**IN THE TENNESSEE REGULATORY AUTHORITY
AT NASHVILLE, TENNESSEE**

**PETITION OF TENNESSEE
WASTEWATER SYSTEMS, INC., FOR
APPROVAL OF CAPITAL
IMPROVEMENT SURCHARGES AND
FINANCING ARRANGEMENTS**

DOCKET NO. 14-00136

**SUPPLEMENT RESPONSE TO STAFF DATA REQUESTS AND TO DISCOVERY
REQUESTS FROM THE CONSUMER ADVOCATE**

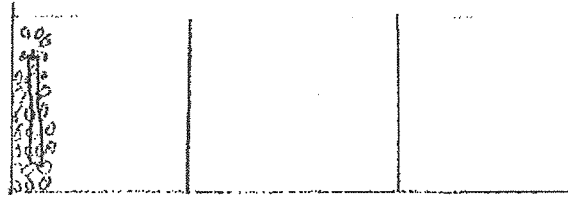
3. A description of plant placement and type. Such placement and type should be in line with the EPA recommendations. The plans mention, "If vegetation is problematic, mechanical aeration and a suspended growth media will be used to simulate plant stalks and plant roots." This is not acceptable. If such a redesign is proposed in the future it will require resubmission of plans.
